*BALLINA SHIRE - FLOODPLAIN RISK MANAGEMENT
EXHIBITION OF STUDY and DRAFT DCP - JUNE 2012*

From: Elle Hayter [relydesigns@internode.on.net]
Sent: Sunday, 1 July 2012 6:45 PM
To: Ballina Shire Council
Cc: Don.Page@parliament.nsw.gov.au
Subject: Submission for Paul Bausmanis,Matthew Wood,Steve Barnier

SUBMISSION ON BEHALF OF THE BALLINA ENVIRONMENT SOCIETY
 THE BALLINA SHIRE FLOODPLAIN RISK MANAGEMENT STUDY AND DRAFT
 AMENDMENT 15 TO THE DEVELOPMENT CONTROL PLAN, POLICY STATEMENT
 11 - FLOOD RISK MANAGEMENT PUBLIC EXHIBITION.

**Re: Submission to Draft Ballina Shire Combined Development Control Plan –
Policy Statement No. 11 – Flood Risk Management.**

TEVEN ROAD FLOODWAY

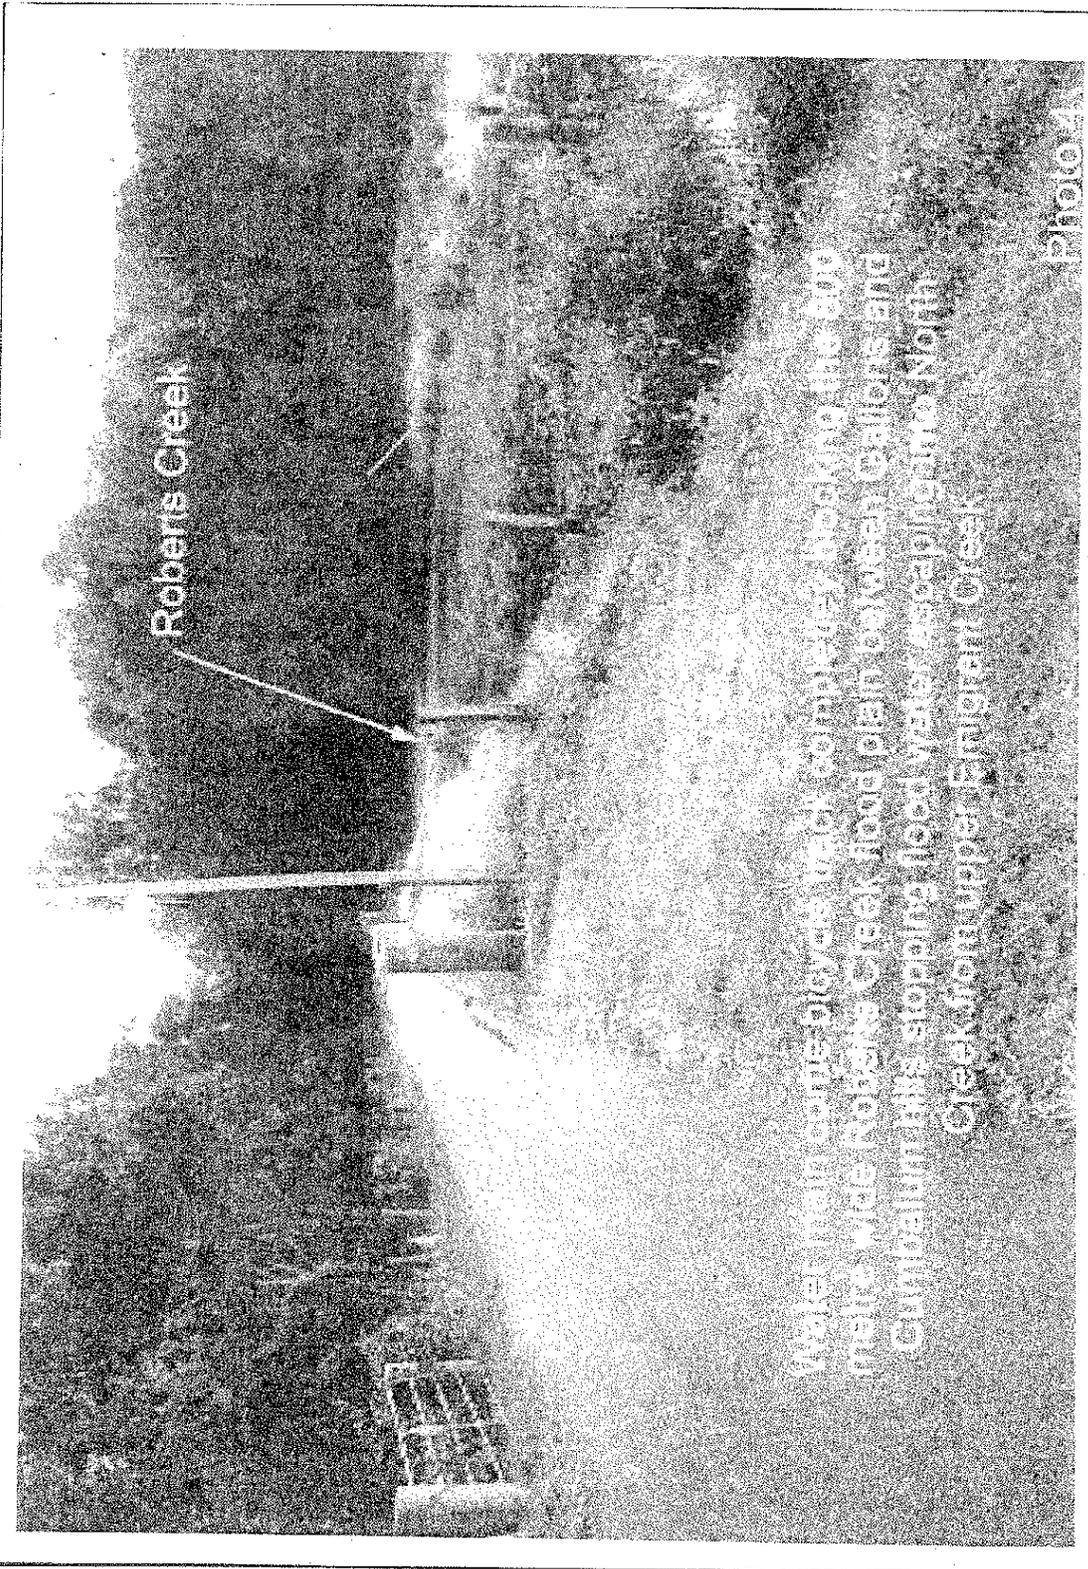
In all councils flood modelling a floodway at 0 AHD was required just east of Teven Road to take floodwater from around Go Grow directly into Emigrant Creek. I request council to construct this floodway as planned and not give way to development to change this crucial floodway.

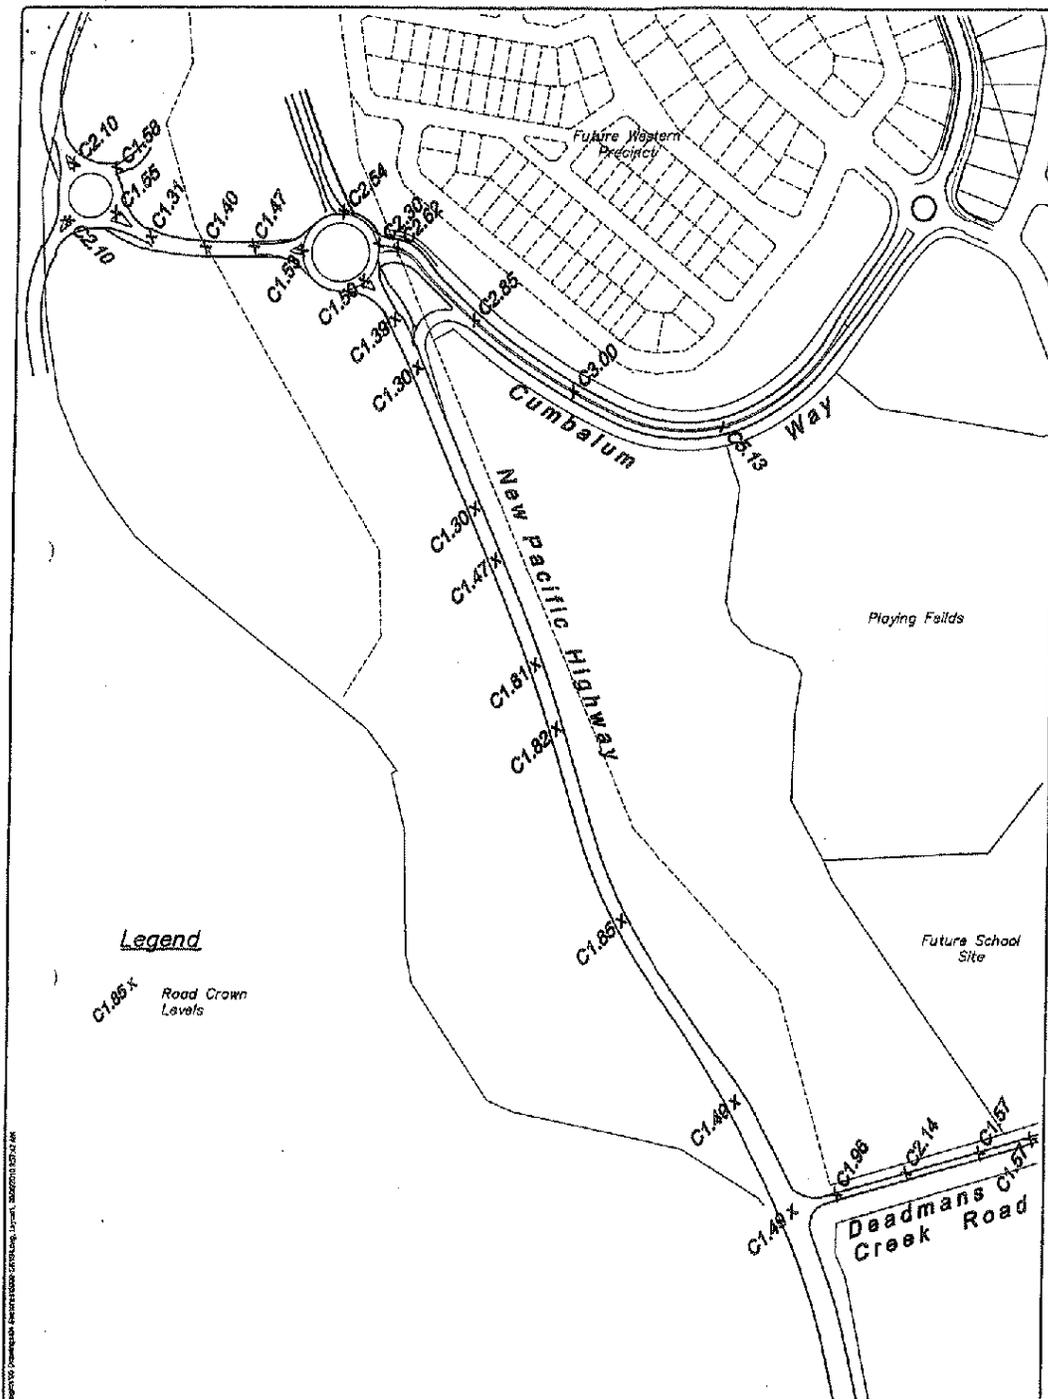
It could be the current levels are not finished levels. However, based on much earlier studies I envisage the levels currently provided will limit access to flood events of less than a 10% probability of exceedance (1:10 year flood). We suggest that this is an unacceptable level and that minimum levels be set @ RL 1.6.
